KWM-380 TRANSCEIVER (622-5093-001, -101)
HF-380 TRANSCEIVER (622-3580-001, -101)
SYNTHESIZER A5A1 (638-6916-001, -002)

SERVICE BULLETIN NO 2**IMPROVE TRANSMITTER SPECTRAL PURITY**

P/O Synthesizer Card A5A1 (638-6916-002)
Figure 2

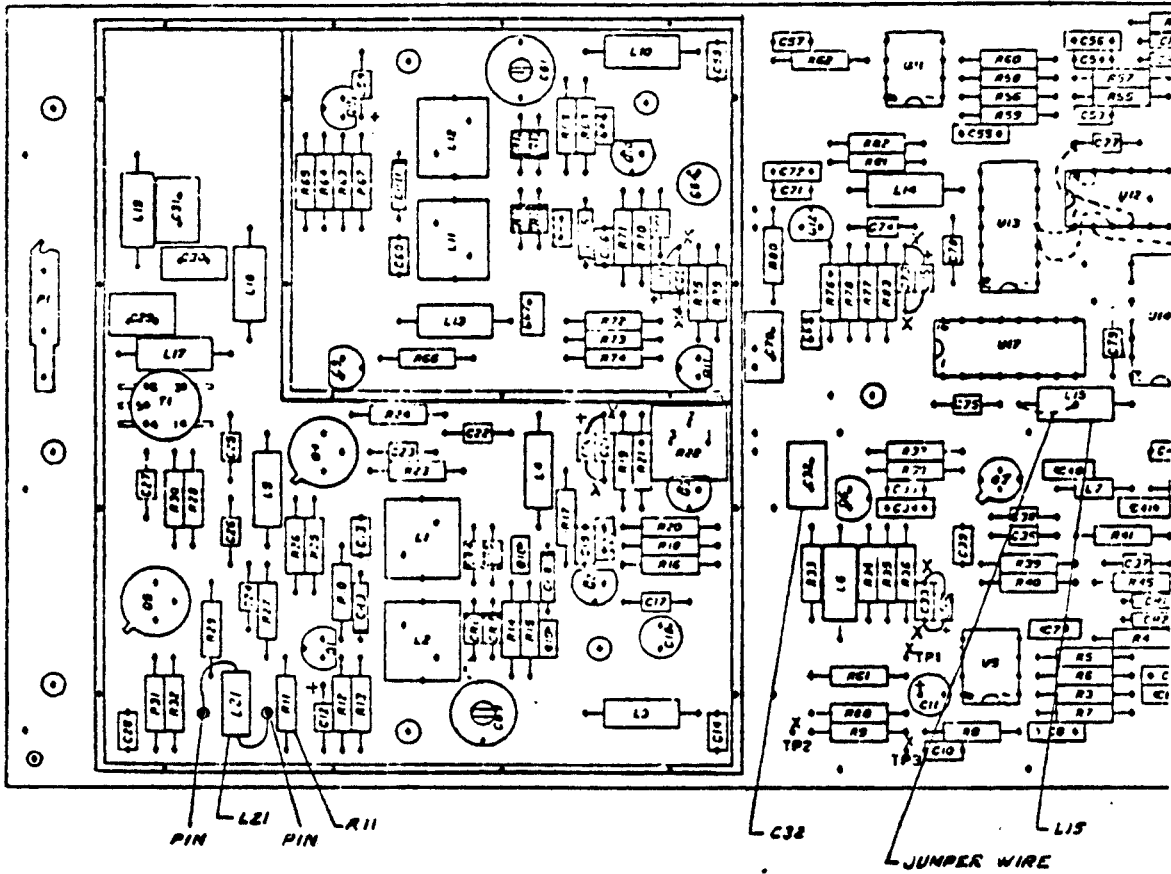
- D. Remove the shield cover from A5A1 card (638-6916-001, -002) by removing 19 screws.
- E. Remove A5A1 from A5 assembly by removing seven screws.
- F. On the top of A5A1, cut circuit trace at right lead of coil L15.

- G. On top of card, cut circuit trace located between thru holes where two new pins are shown in figures 1 and 2.
- H. From the top of the card, insert pins (372-2656-130) into two thru holes as shown in figures 1 and 2.

- I. Connect 4.7- μ H coil (240-1576-000) between the two new pins. Use sleeving (152-2483-000) on L21 leads if needed.
- J. Remove the 27-pF capacitor C32 and replace it with an 18-pF capacitor (913-1098-030).

- K. On the bottom of the card, install a jumper wire (428-0282-050) from the left lead of L15 to the thru hole located under L15.
- L. Mark RWK REV G on the card near the part number.
